Re: Proposed Townhomes at Woodbank 0 Warburton Avenue

As the Architect representing PTG Development, LLC, owner of 0 Warburton Avenue, I am submitting the attached revised drawings, dated May 4, 2017, describing six new townhouses at 0 Warburton Avenue, for site plan, view preservation, and steep slopes review. Our submission consists of the following drawings:

In response to comments made by the Planning Board at the meeting on March 16, 2017, the drawings were revised, and additional drawings were prepared, as follows:

SOUTH ELEVATION - COMPARISON TO PREVIOUS SUBMISSION

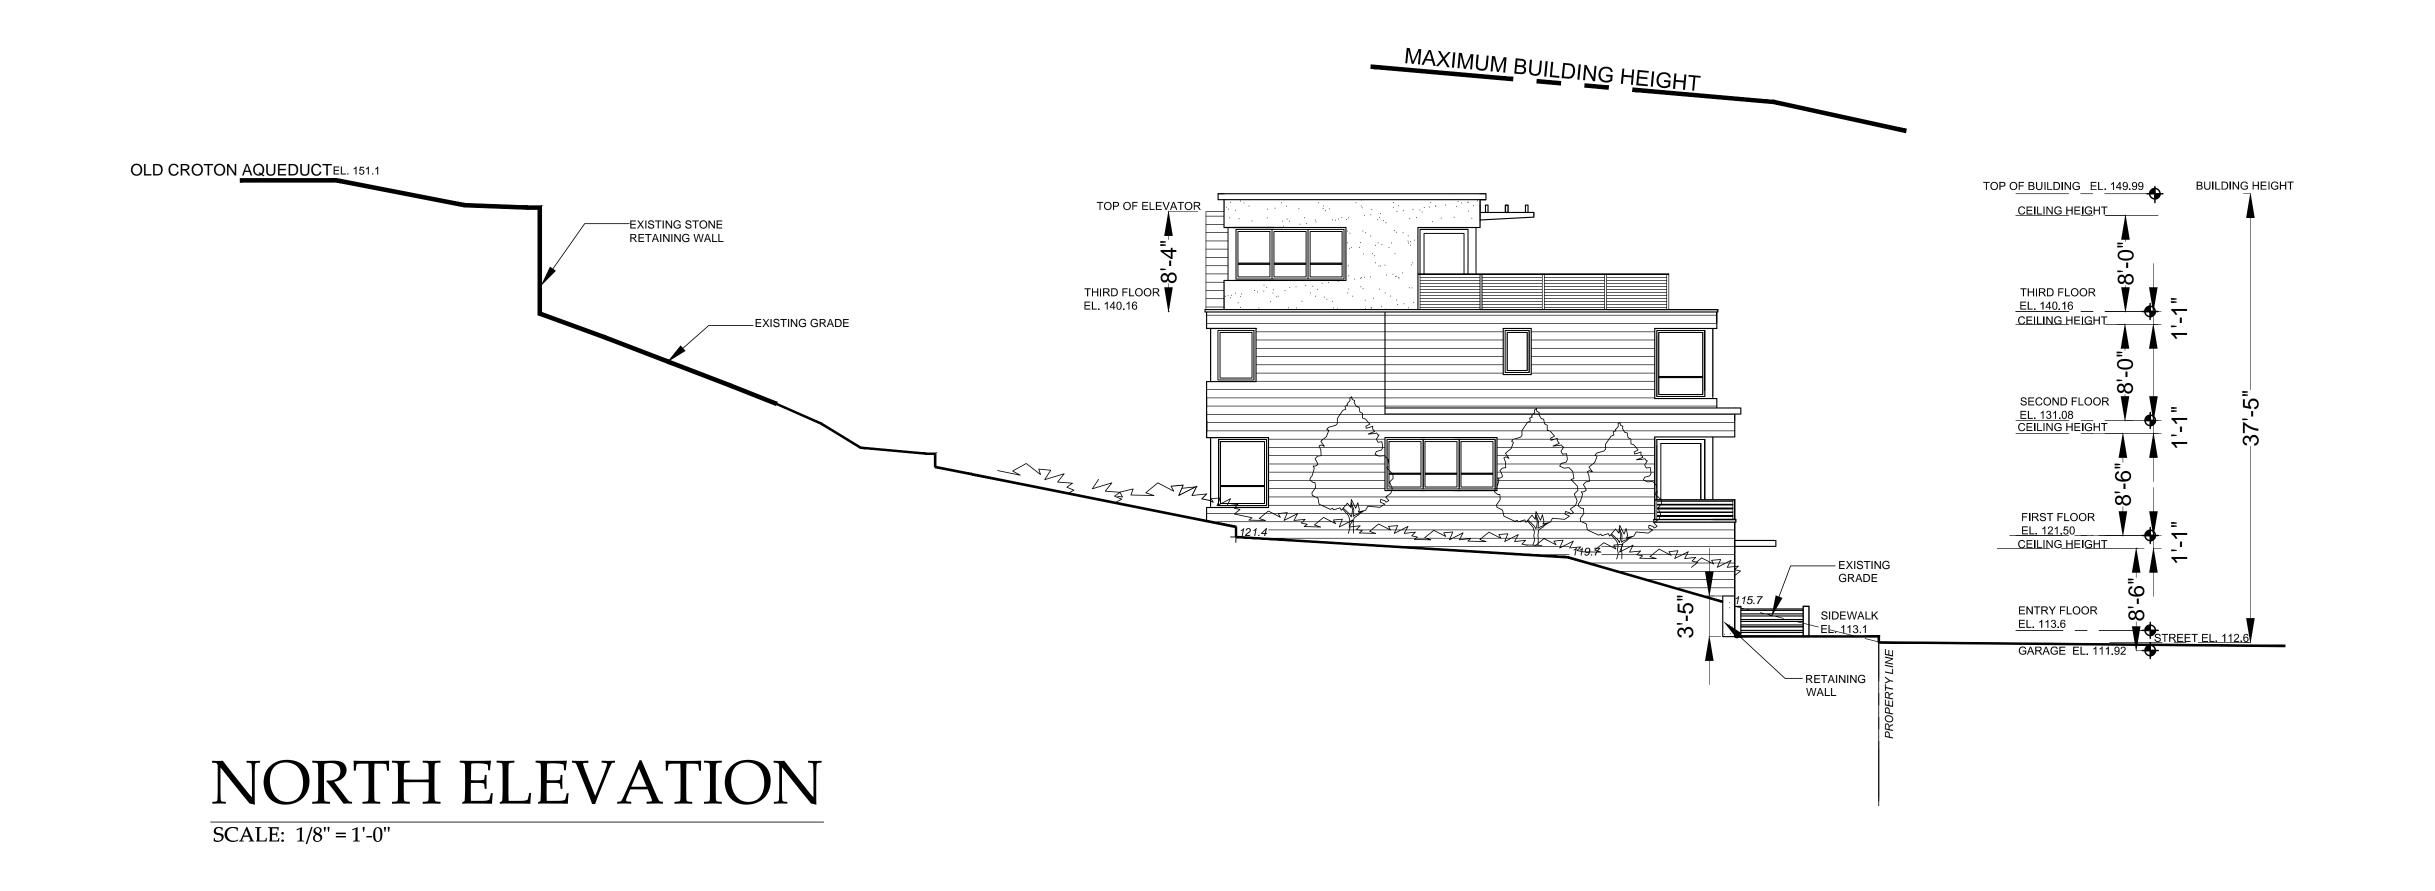
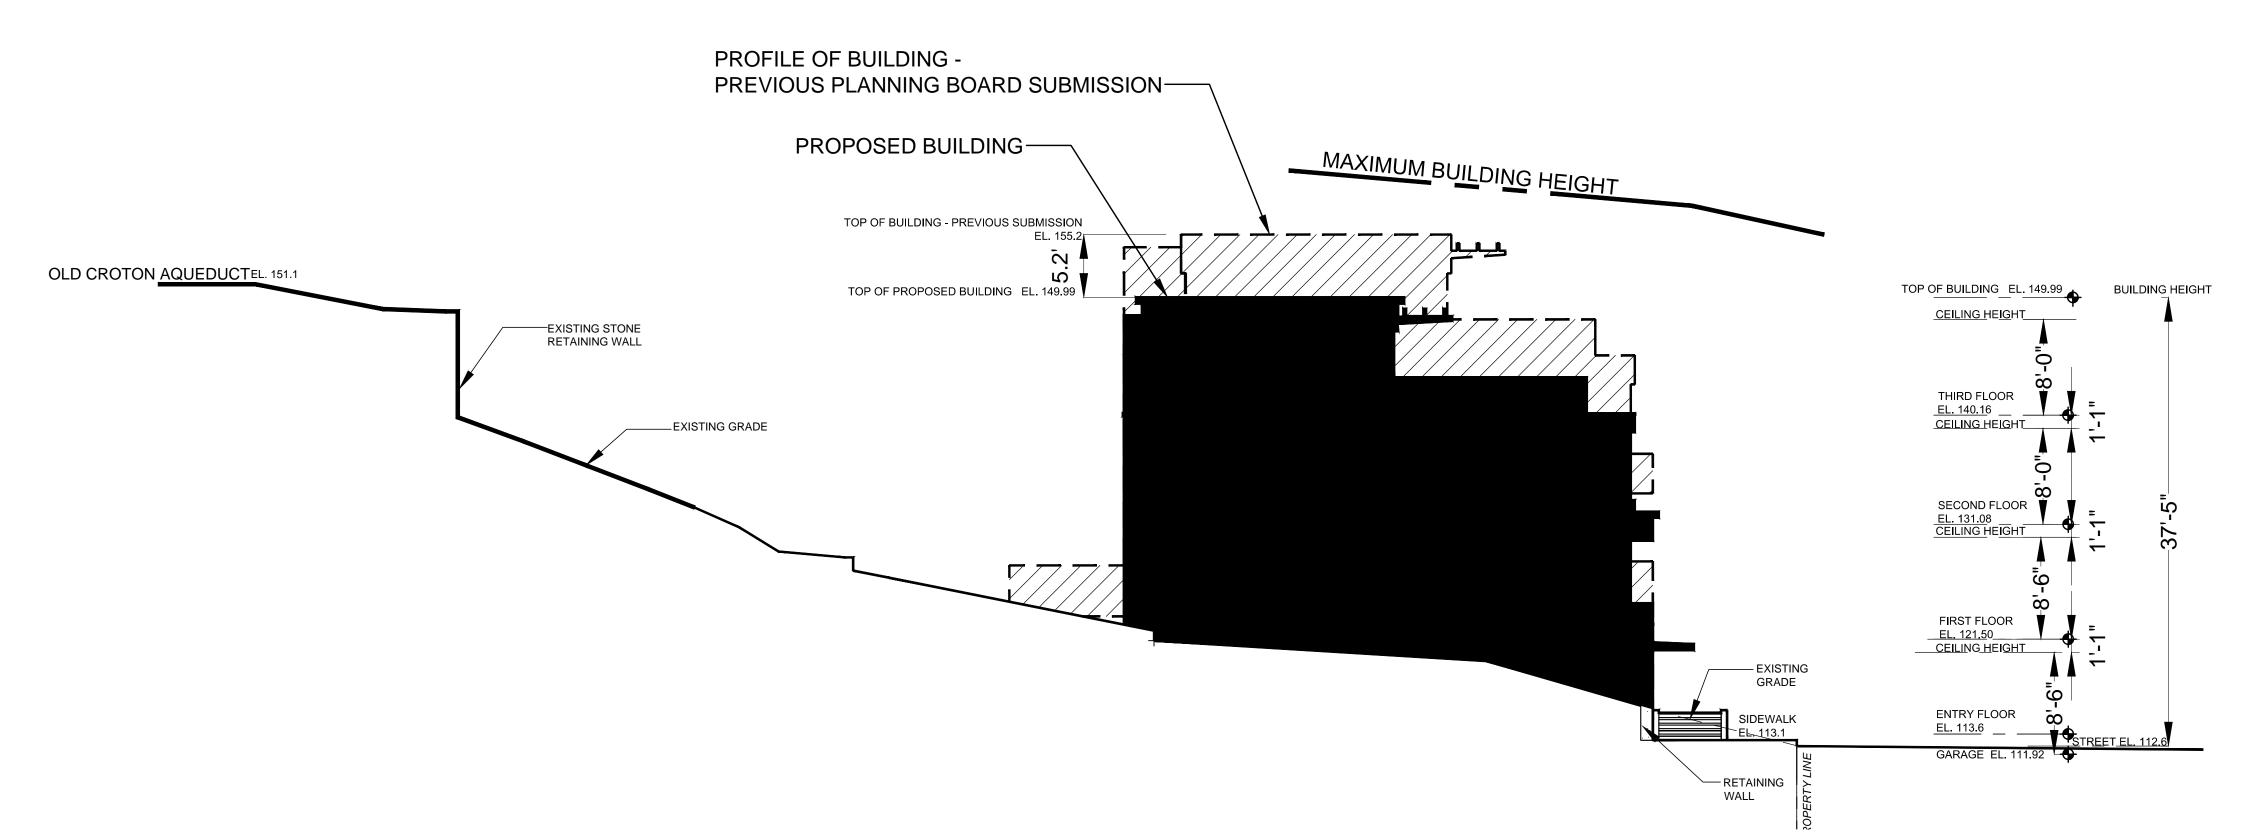
- 3. The total open space area has increased to 9,294 SF from 7,836 SF.
- 4. The proposed building is 5.2 feet lower than the previously submitted building, due to the newly established street elevation of 112.6 and due to the lowering of the ceiling heights at the garage, first floor and second floor. See revised elevations A-4 – A-7, and revised view studies VP-1 – VP-12.
